### United States Patent and Trademark Office

APPLICATION NO.	FILING DATE	FIRST NAMED INVENTOR	ATTORNEY DOCKET NO.	CONFIRMATION NO.	
09/748,277	12/27/2000	00 Jae-Lag Ma		8733.363.00 4729	
30827	7590 10/10/2003	EXAM	EXAMINER		
MCKENNA 1900 K STR	A LONG & ALDRIDGI	RUDE, TIM	RUDE, TIMOTHY L		
WASHINGTON, DC 20006			ART UNIT	PAPER NUMBER	
			2871

#### **DETAILED ACTION**

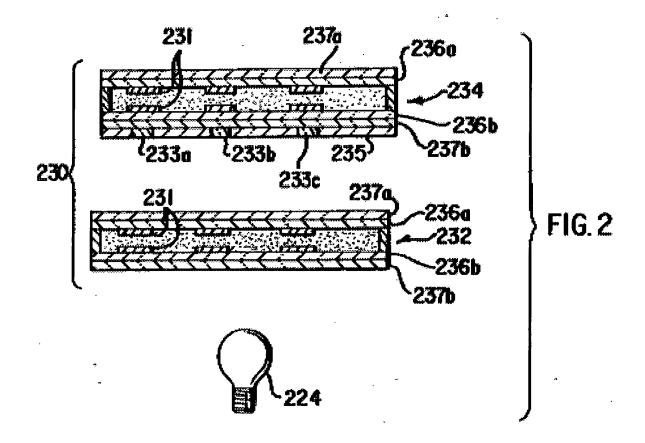
As to claims 6 and 9-11, Dingwall teaches in Figures 2 and 3 (col. 5, lines 33-40 and col. 7, line 60 through col. 8 line 28), a liquid crystal display (LCD) device, comprising:

an upper polarizer, 237a; on an upper substrate, 236a;

a lower substrate, 236b, on a lower polarizer, 237b, (Applicant's redundant lower substrate); a liquid crystal layer disposed between the upper substrate and the lower substrate; and a backlight device, 224, disposed opposite and adjacent to the lower polarizer for emitting light toward the lower polarizer (Figure 4) (please note that adjacent does not preclude structures between those items considered to be adjacent, e.g., two houses may be adjacent despite the existence of an intervening garage); wherein the lower polarizer includes at least one opaque surround or black mask, 235, (Applicant's light shielding film), formed in a rectangular shape only along the peripheral portion of the lower polarizer (235 shaped to run along all four sides of only the rectangular lower polarizer as illustrated in Figure 3) wherein the black mask absorbs light (col. 8, lines 29-33, and col. 13, lines 25 and 26).

FIG. 3

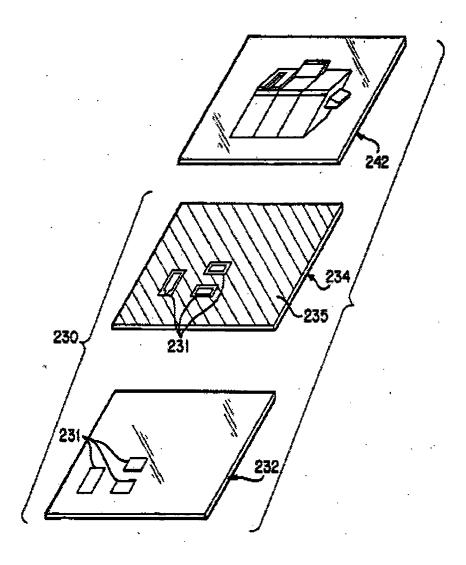
As to claims 7 and 8, Dingwall teaches (col. 8, lines 11-28) a liquid crystal display (LCD) device of claim 1, wherein the at least one opaque surround or black mask, 235, (Applicant's light shielding film) is formed by a photographic process, by offset lithography (Applicant's coating), or by screen printing (Applicant's printed material) black mask materials that absorb the light (col. 8, lines 29-33, and col. 13, lines 25 and 26).
